Re: Boulevard Parking Application
Mr. Dan Bursic
552 Colborne Street
Our File: BSC/LON/14-01

RE: BOULEVARD PARKING, 552 COLBORNE STREET

I have reviewed the material you sent me with respect to the application to permit three boulevard parking spaces in front of 552 Colborne Street. You have requested my opinion on the safety and functionality of the proposed layout.

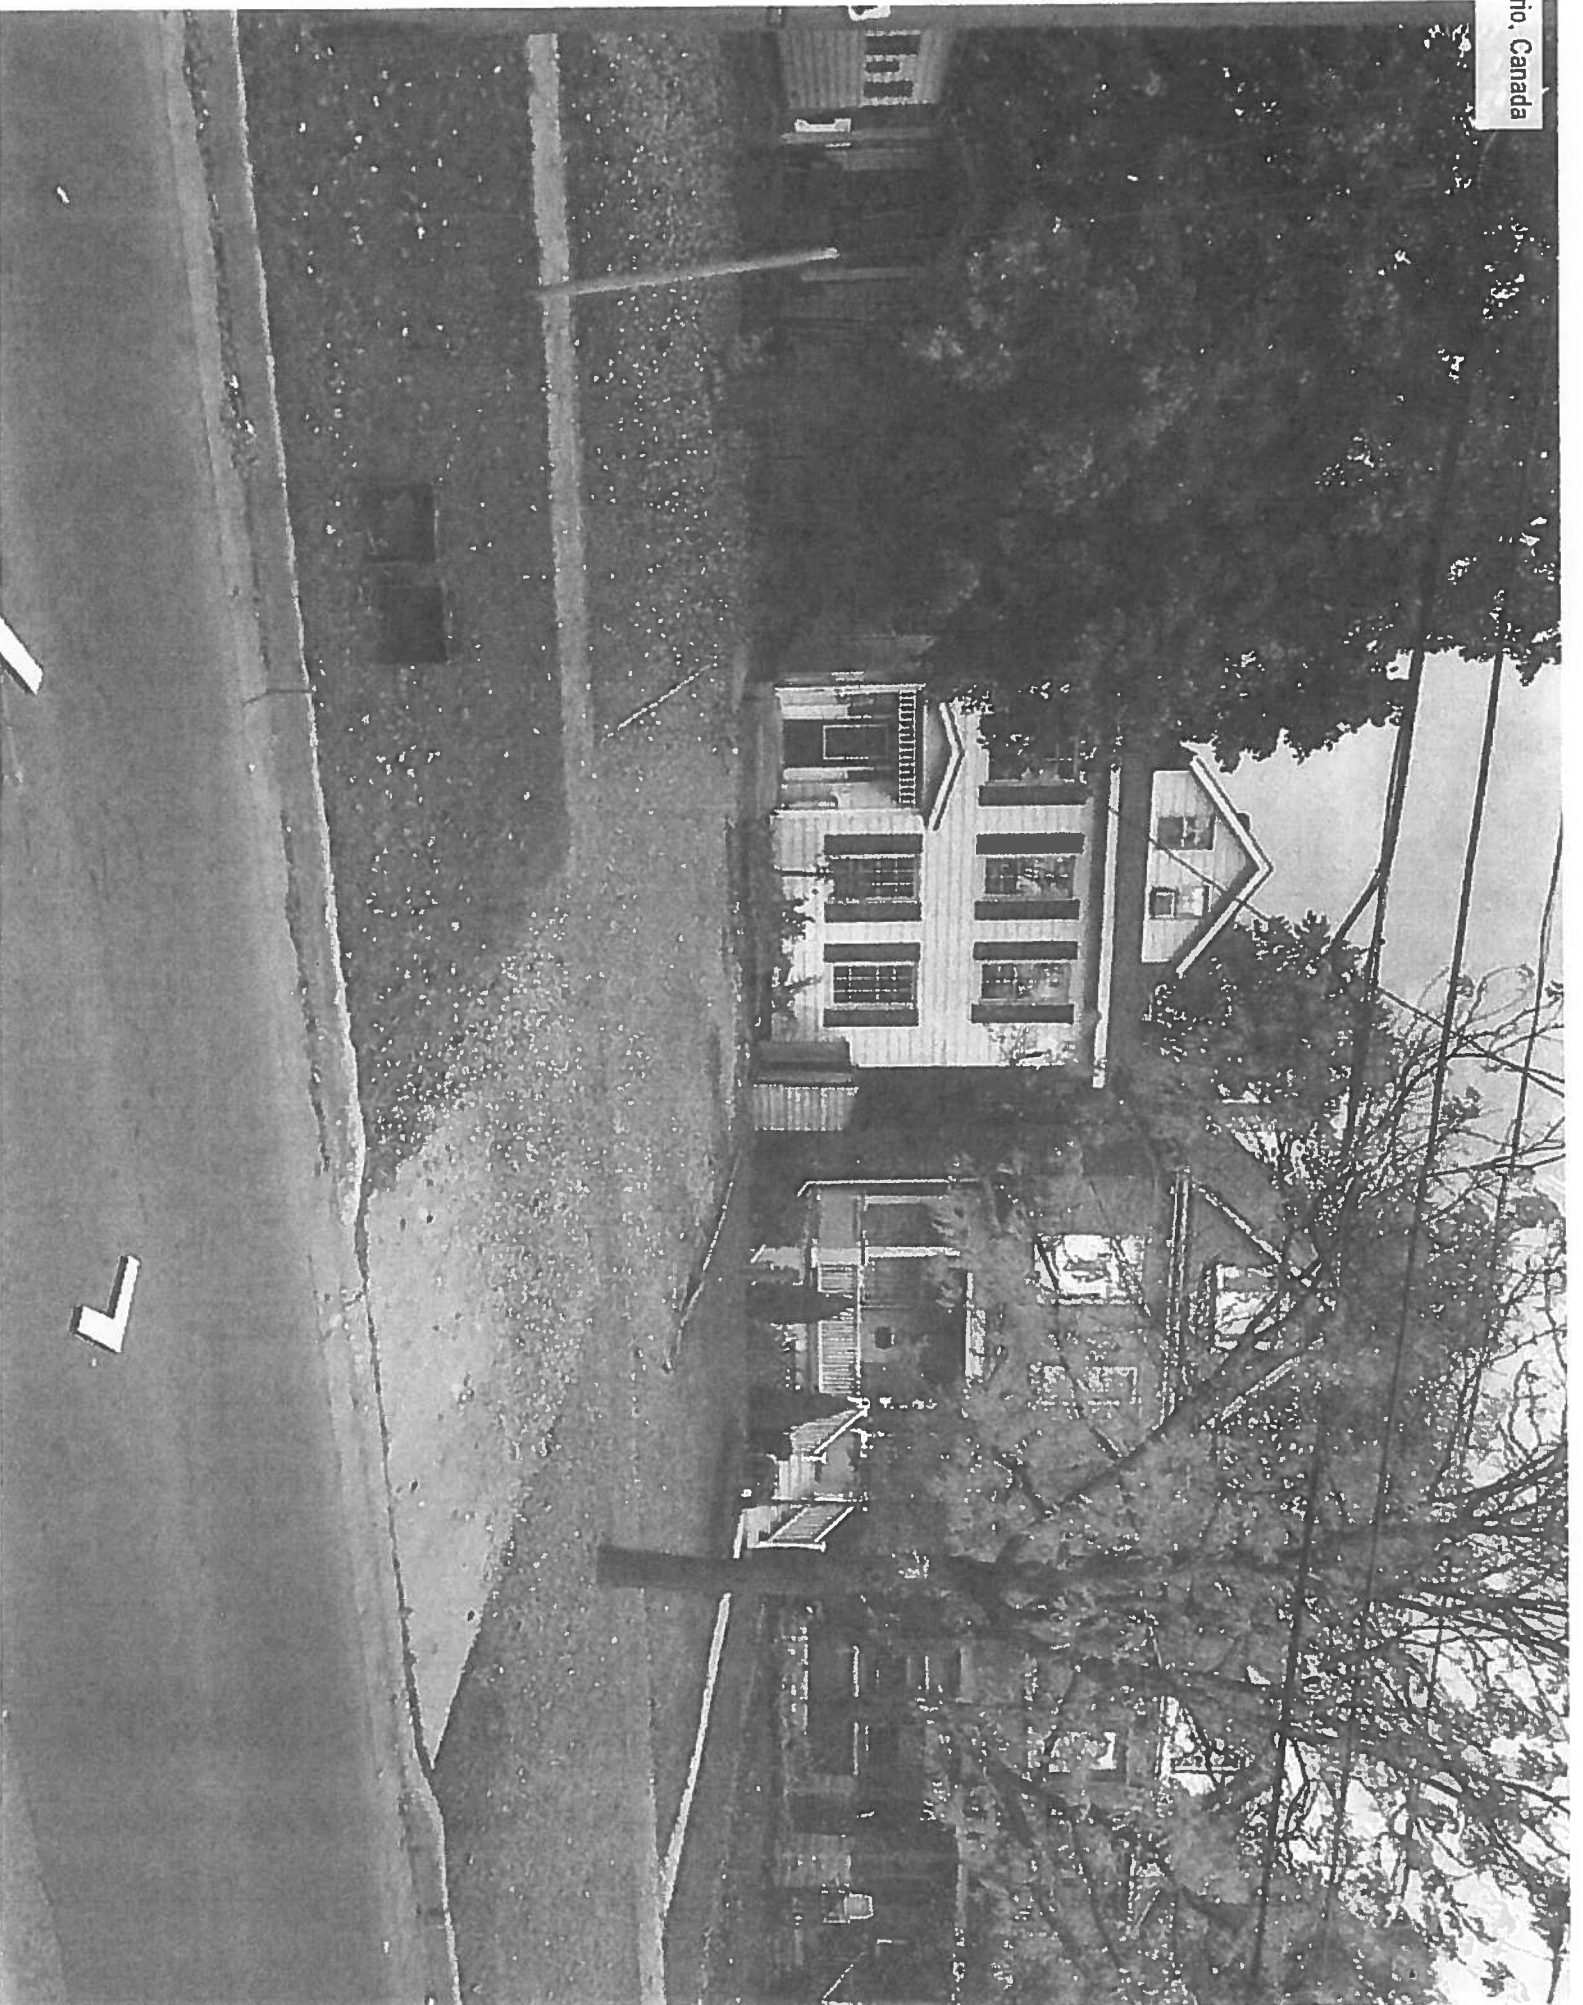
I understand that the three parking spaces are currently in use. The photograph shows no evidence of vehicle tracks crossing the existing grassed area, which suggests that drivers using the southerly parking space are able to manoeuvre in and out without encroaching on the grassed area.

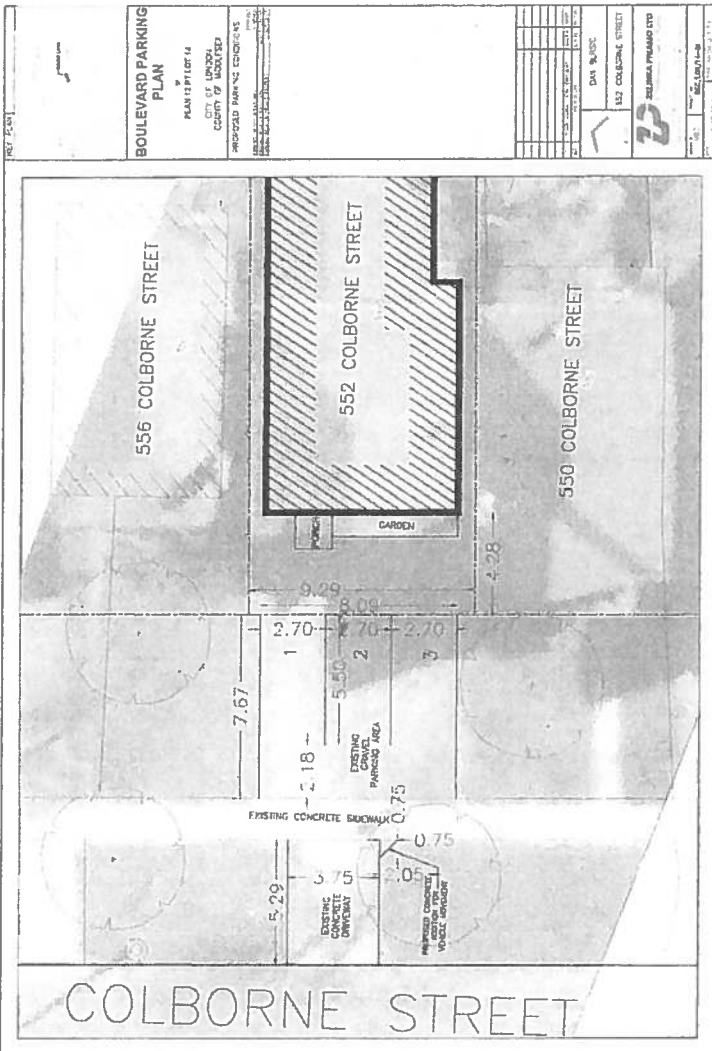
Your proposed layout incorporates a paved triangle on the west side of the sidewalk, presumably to provide more manoeuvring space. I do not believe that the paved triangle as proposed would provide much benefit. It should either be larger (say 1.5 metres by 1.5 metres) or eliminated altogether.

The layout shows three parking stalls, each 5.5 metres long by 2.7 metres wide. The total depth available in front of the building is 7.67 metres, thus allowing a clearance of 2.17 metres between the edge of the sidewalk and the end of the parking stall. While vehicle lengths vary, only older model full size cars approach a length of 5.5 metres. For example, a Honda Civic has an overall length of 4.5 metres while a Dodge Journey has an overall length of 4.9 metres.

The space available at 552 Colborne Street to park cars is greater than that identified above, in terms of both stall width and length. It follows, therefore, that there is more space available for drivers to manoeuvre within the existing parking area.

Any vehicle manoeuvre which crosses a pedestrian walkway, including the use of driveways, creates a potential hazard. In most cases, drivers enter a driveway going forward and reverse out. The situation with boulevard parking is no different. In this case, two of the available parking stalls have a relatively direct entry and exit. The third stall requires an "S-turn" manoeuvre. Somewhat paradoxically, it has often been observed that, the more complicated the driving manoeuvre, the safer it is. This is because drivers are aware of potential hazards and exercise more caution.

In summary, while no boulevard parking arrangement can be considered completely safe, the fact that a driver would have to turn to enter or leave a parking space does not make such a space inherently more hazardous than any other space. In my opinion, the application for a boulevard parking permit for three spaces is justified.
